# Leland Reservoir Replacement Project Final Environmental Impact Report

## Volume III – Responses to Comments

SCH #2016082082

Volume III

**NOTE:**  
 • Photo from 1050 Leland Drive was taken at the driveway curb

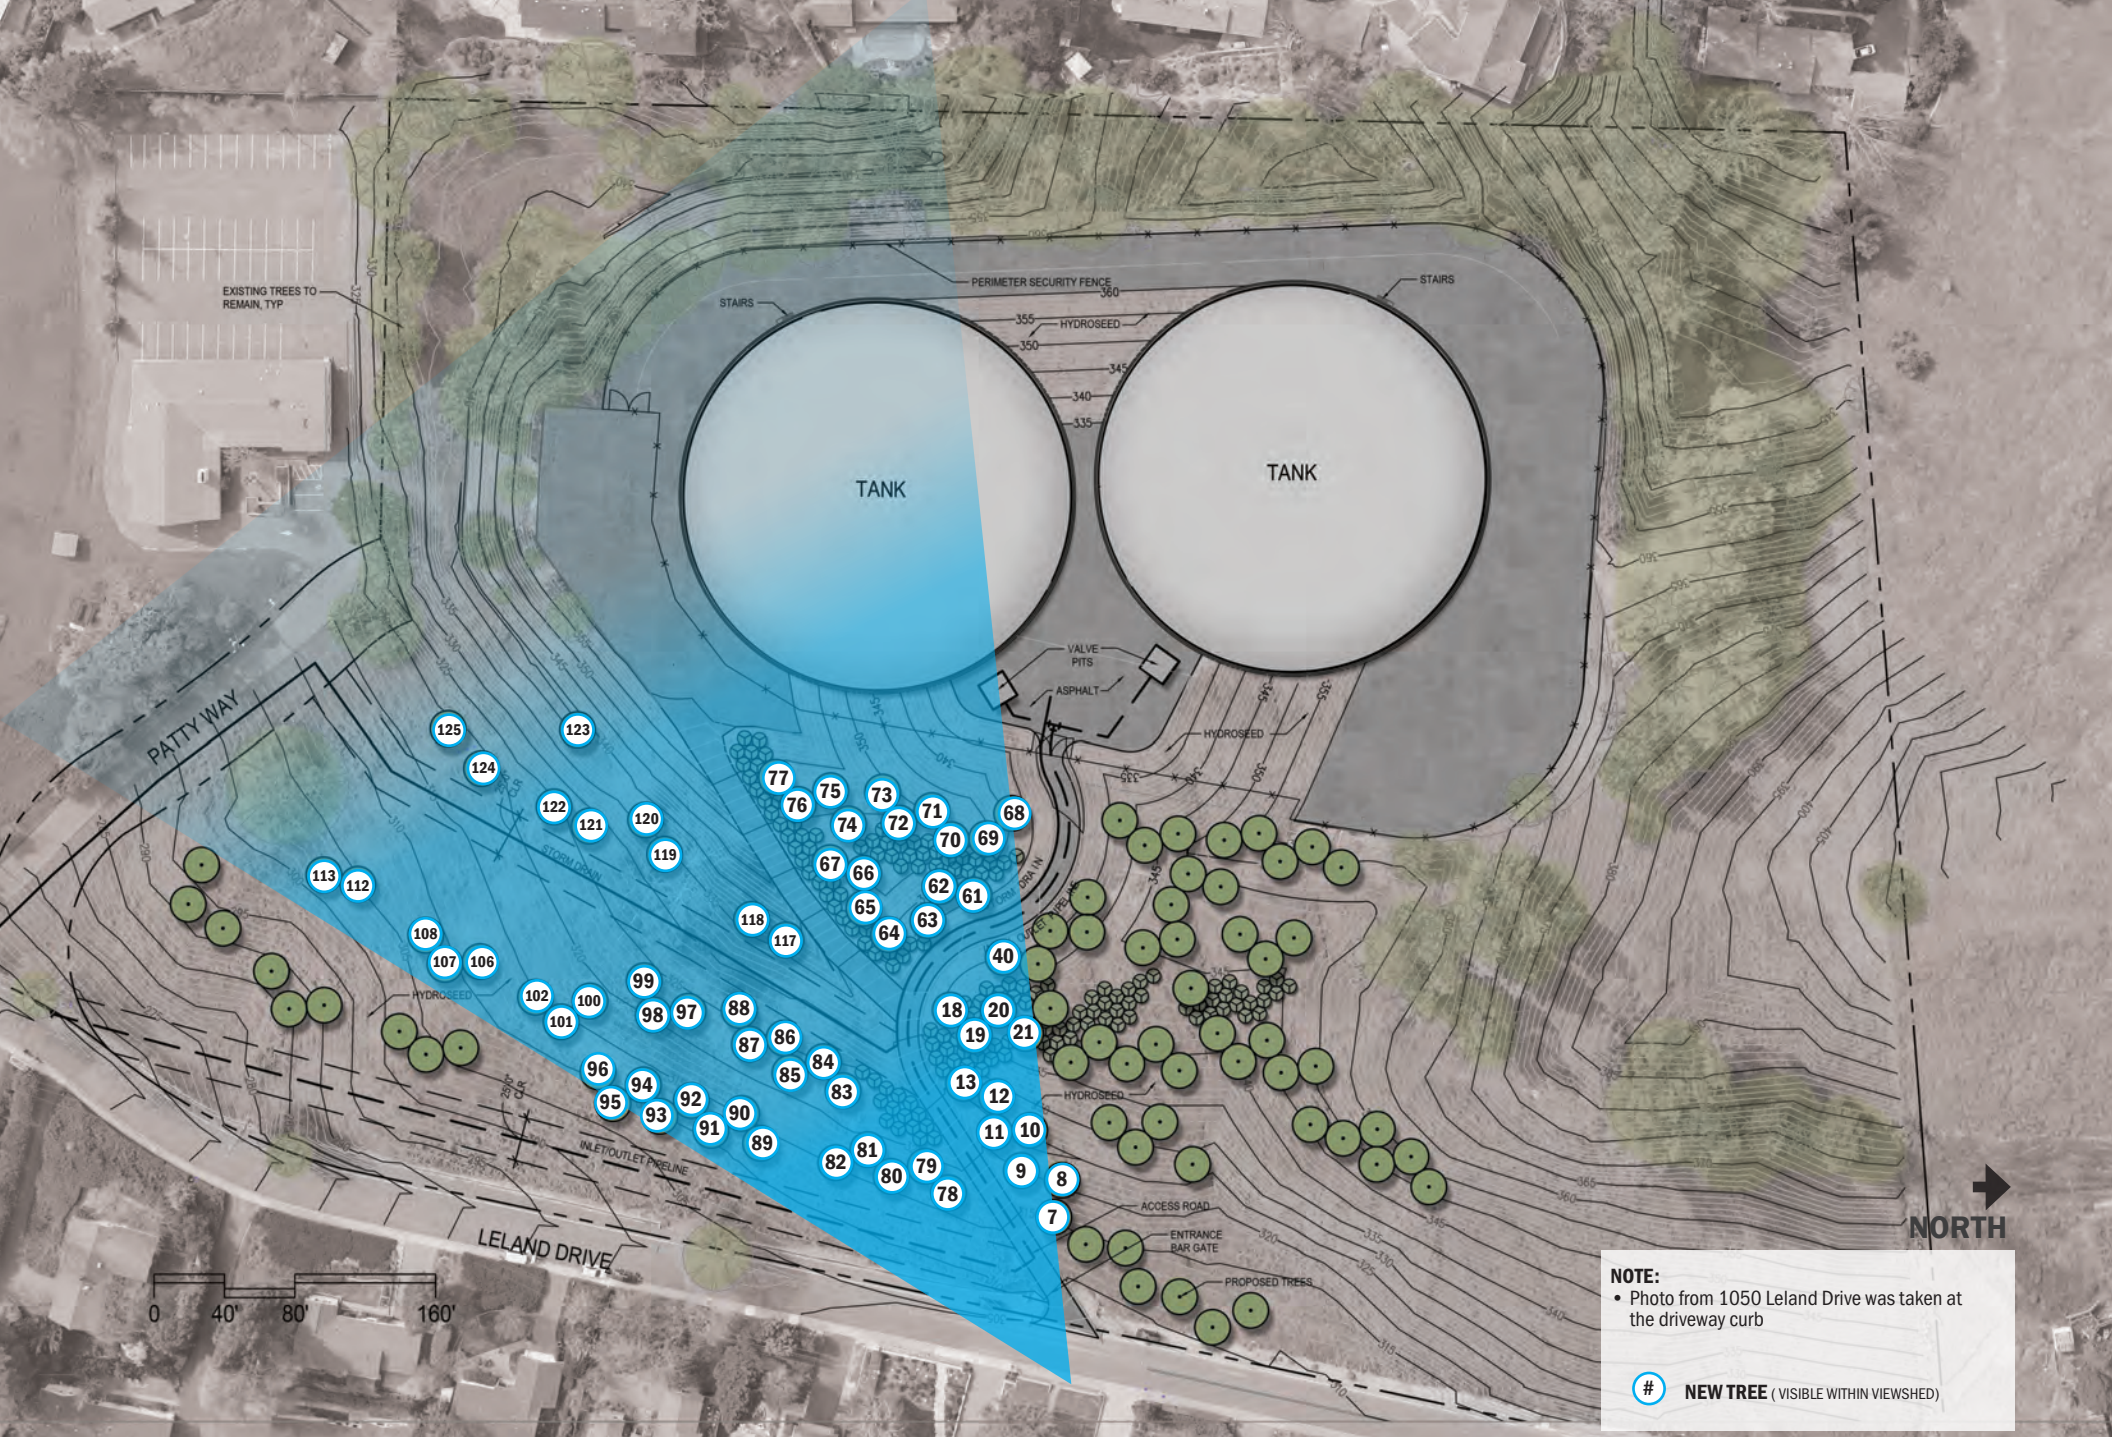
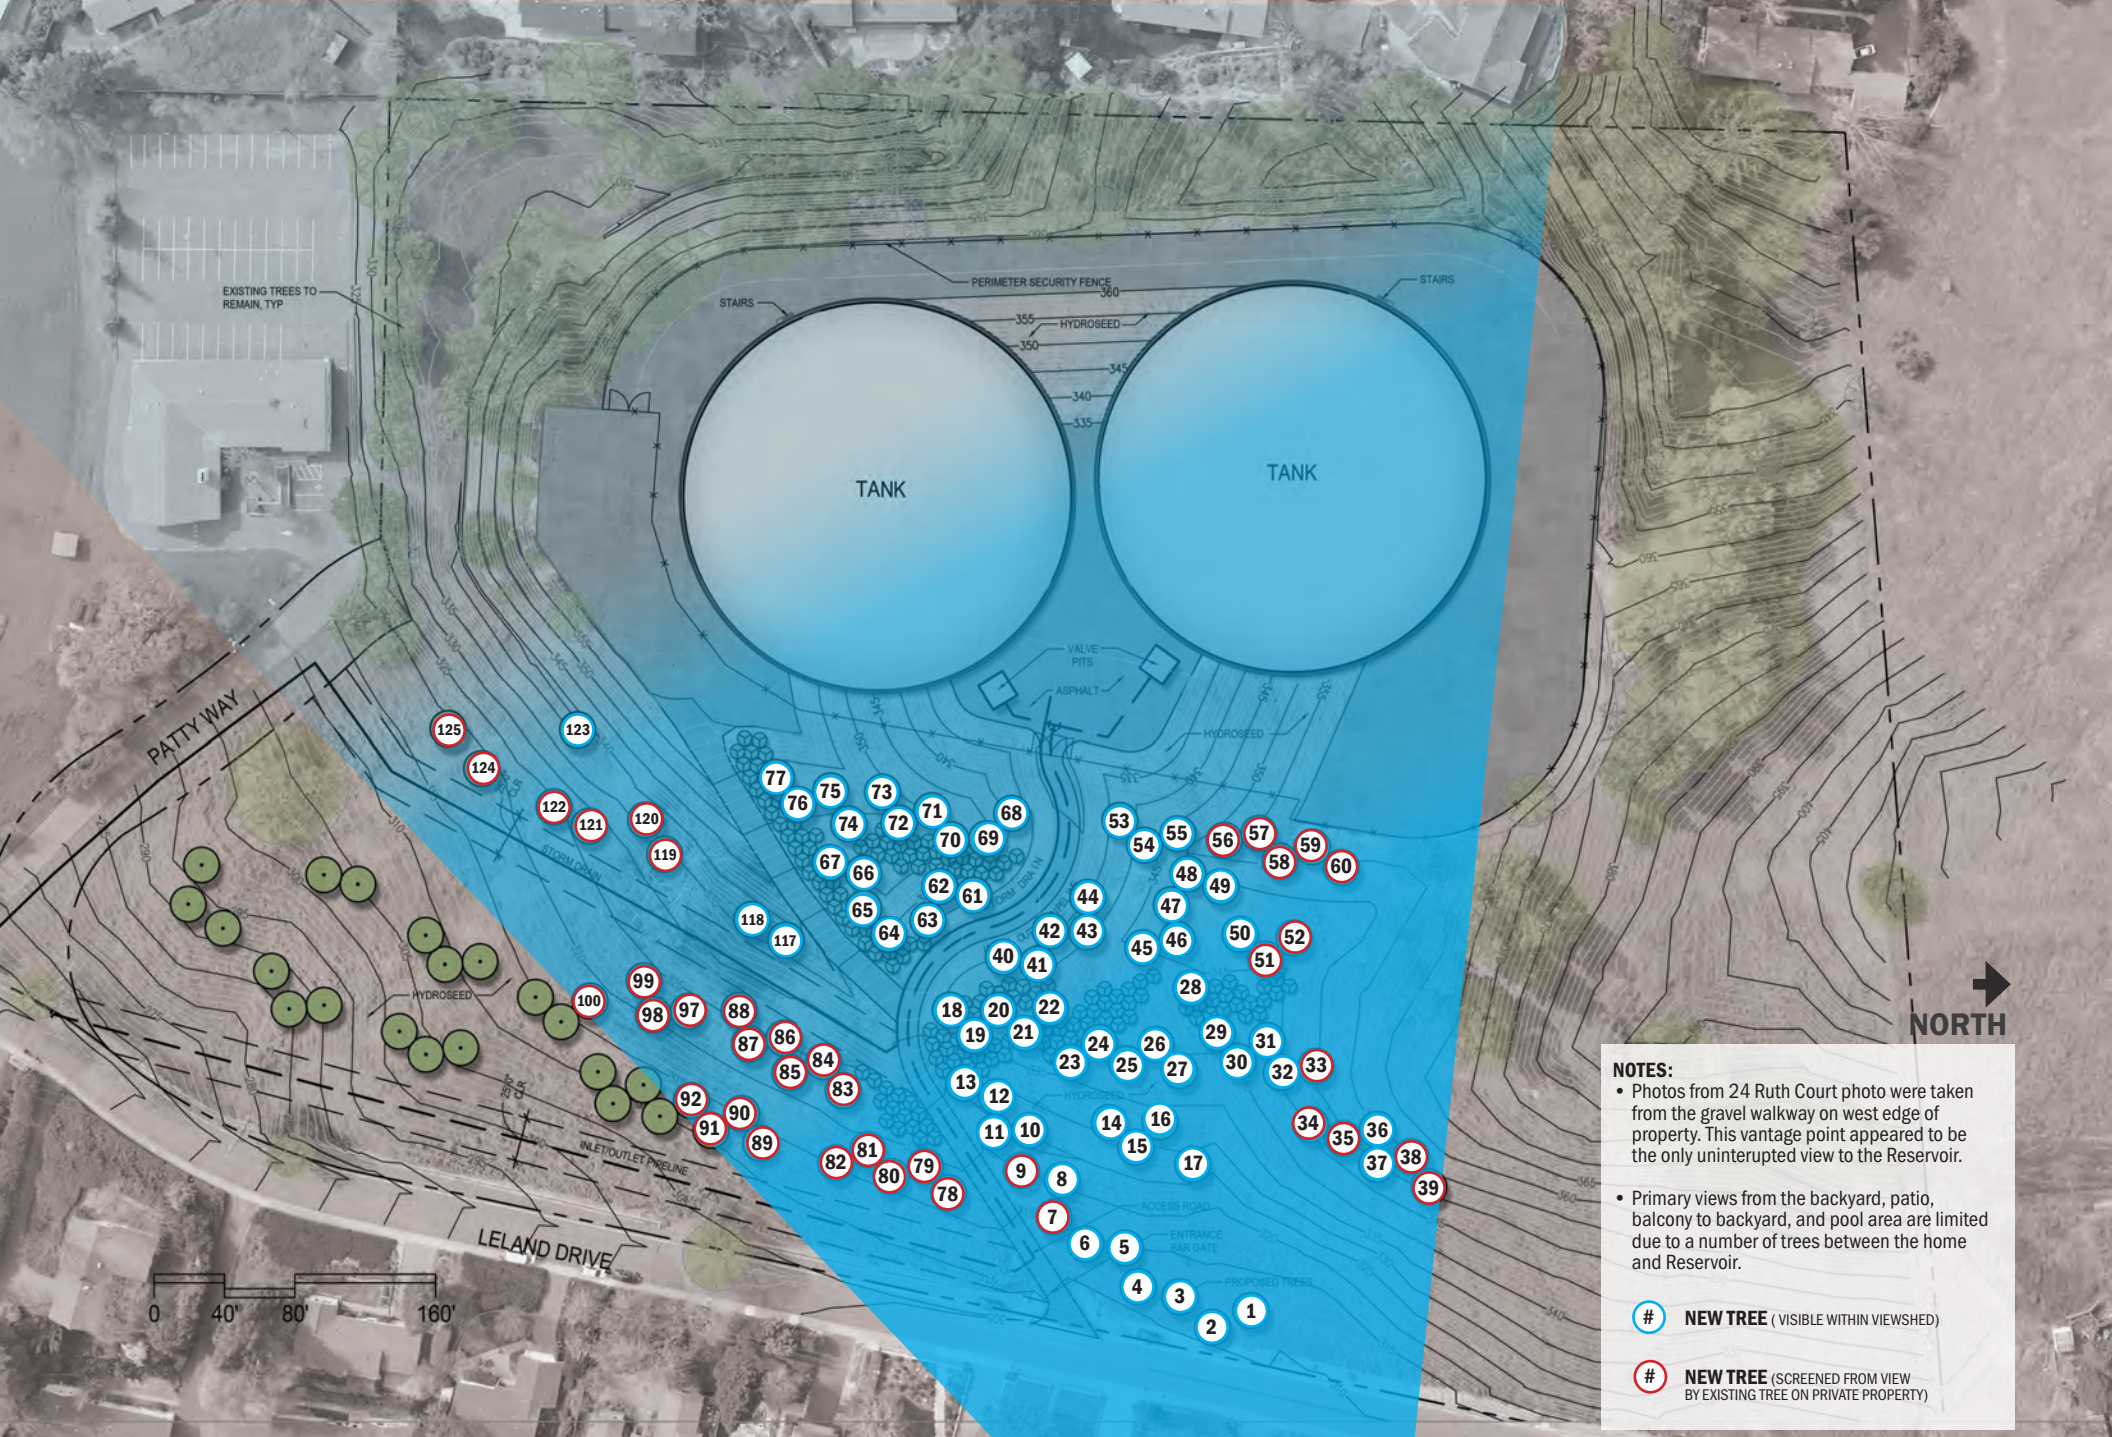
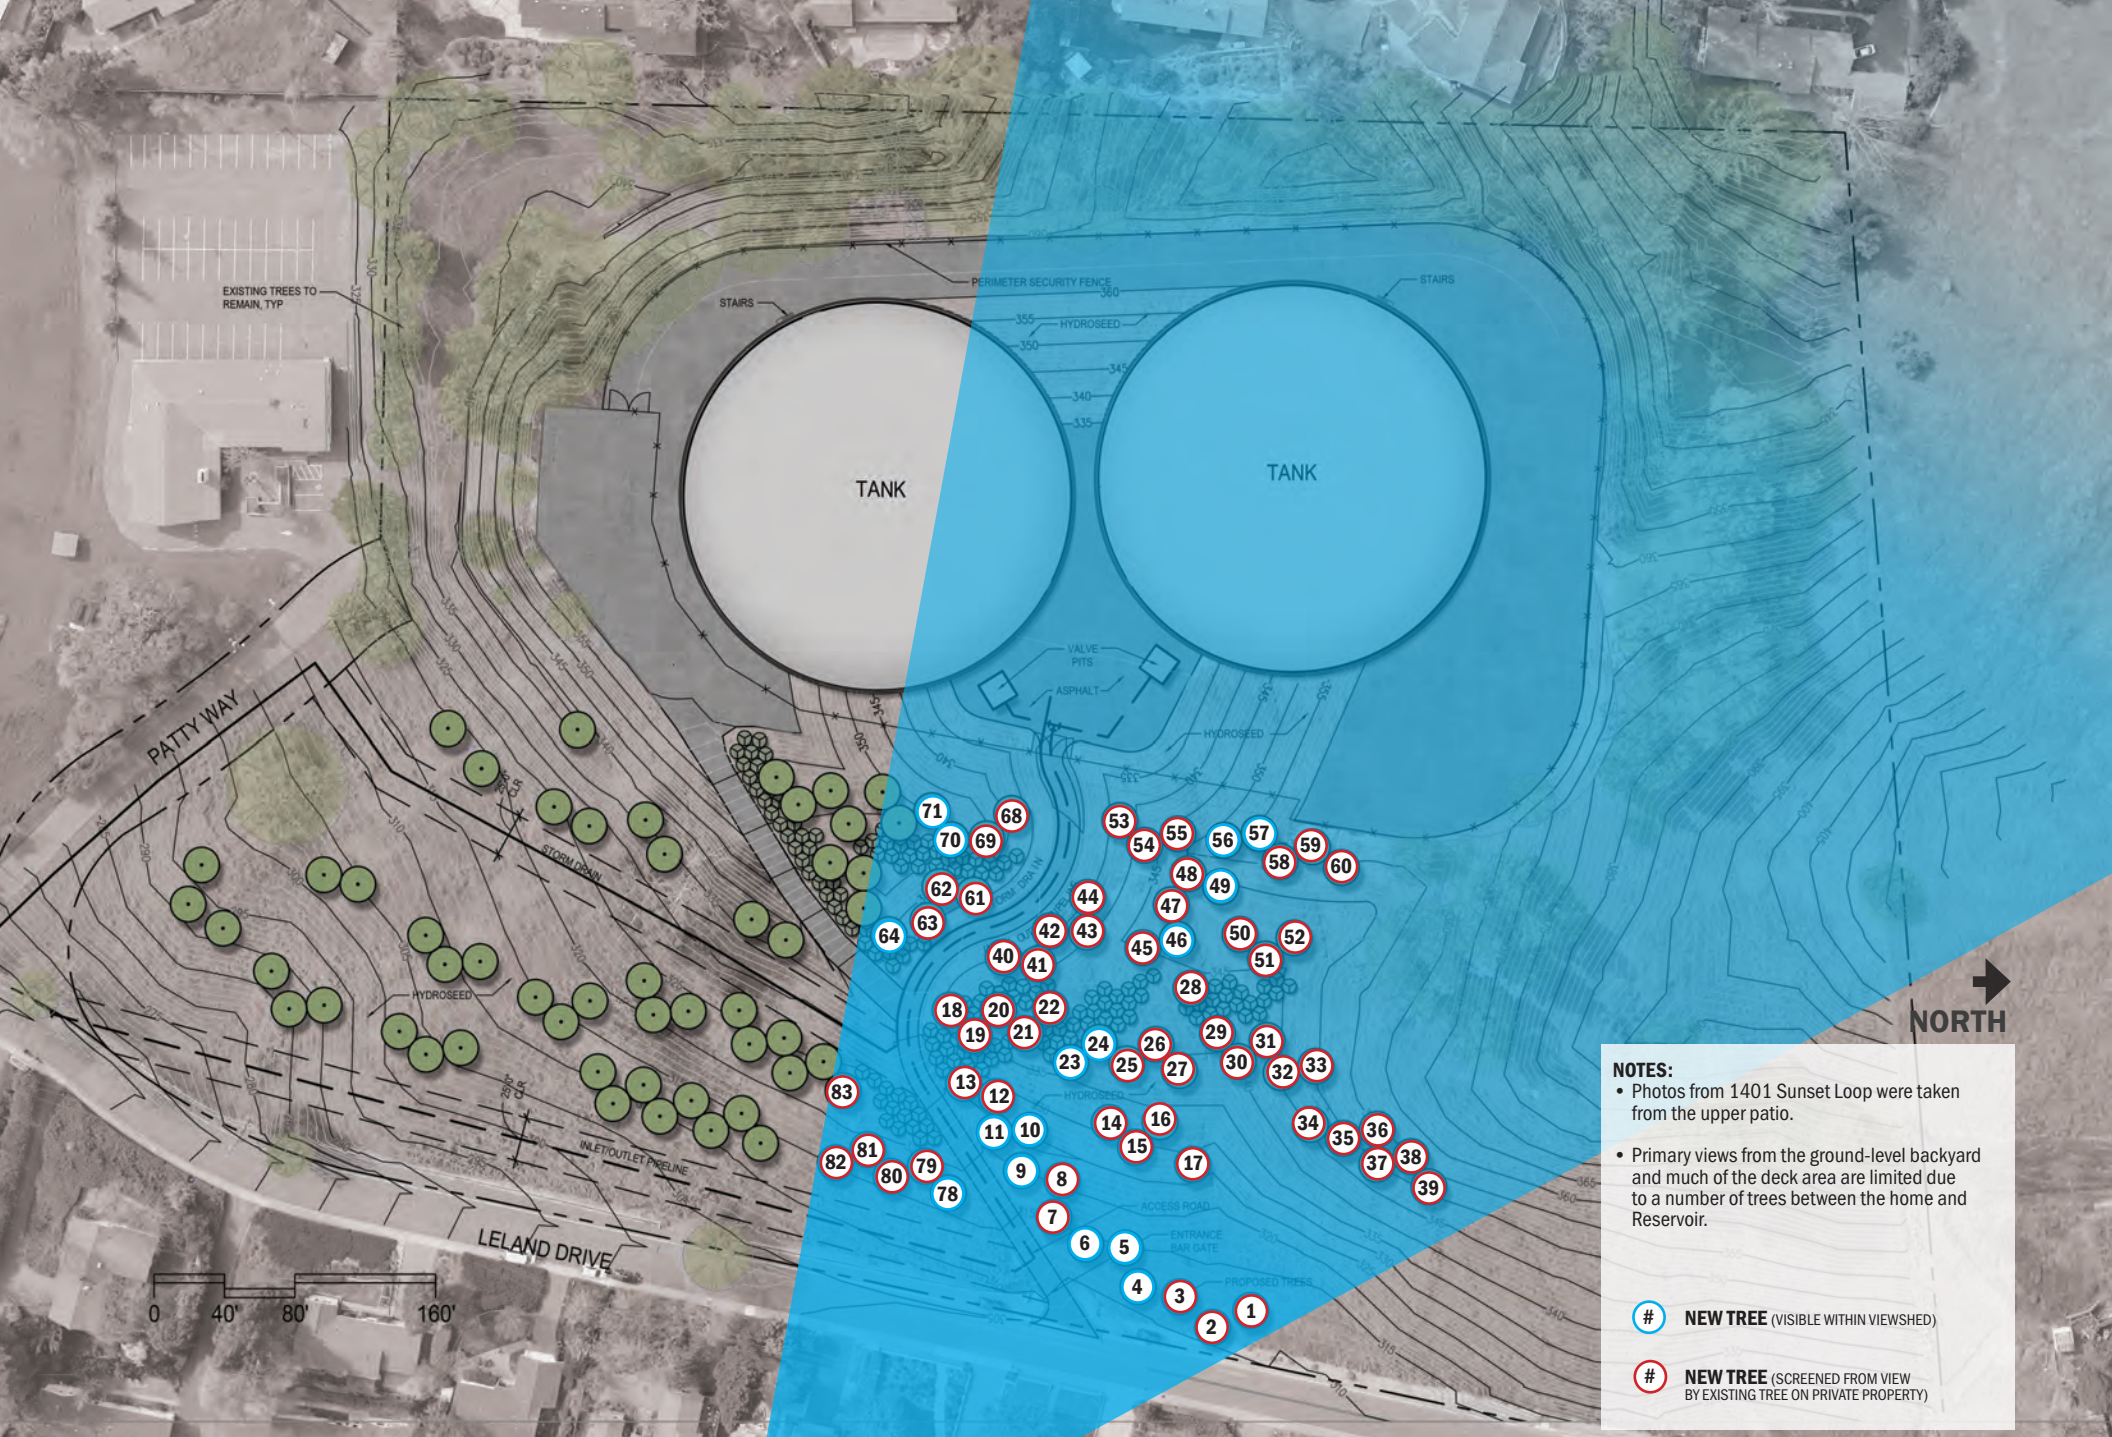
Comments from neighbors included some specific requests for viewpoints along Leland Drive. Visual simulations showing the revised landscape plan are provided for all three of the viewpoints depicted on pages 3.1-9 through 3.1-11 in the Draft EIR for 1040 Leland Drive, 1050 Leland Drive, and 24 Ruth Court. The Draft EIR included photographic simulations from public viewpoints at 1040 Leland Drive and 1050 Leland Drive and a computer rendering of the simulated view from the private backyard of 24 Ruth Court. The revised simulation for 24 Ruth Court now includes a photographic simulation because the resident provided access to the backyard, enabling a more accurate representation of the view from the site than was provided in the computer simulated view. The reservoir and location for the proposed tanks is not visible from most of the backyard at 24 Ruth Court, so the viewpoint is from a portion of the yard that is not typically used for outdoor gatherings. Photographic simulations of two additional viewpoints have also been included: 1401 Sunset Loop and 1048 Leland Drive. The view from the backyard of 1401 Sunset Loop provides another simulation from a higher elevation. The view from 1048 Leland Drive looks directly west at the point where the entrance road would enter the tanks as requested in comments

from Leland Drive residents. To address concerns about how the reservoir site would look immediately after construction, additional visual simulations are included to show the Project appearance immediately post construction, five years after construction, and fifteen years after construction.

The following new and updated visual simulations are included in the Final EIR at the end of this Master Response:

- 1040 Leland Drive (updated from Figure 3.1-2 in Draft EIR) – post construction, 5-year projection, 15-year projection
- 1048 Leland Drive (new view directly west to entrance road) – post construction, 5-year projection, 15-year projection
- 1050 Leland Drive (updated from Figure 3.1-3 in Draft EIR) – post construction, 5-year projection, 15-year projection
- 24 Ruth Court (updated from Figure 3.1-4 in Draft EIR) – post construction, 5-year projection, 15-year projection
- 1401 Sunset Loop (new view from backyard of adjacent residence) – post construction, 5-year projection, 15-year projection
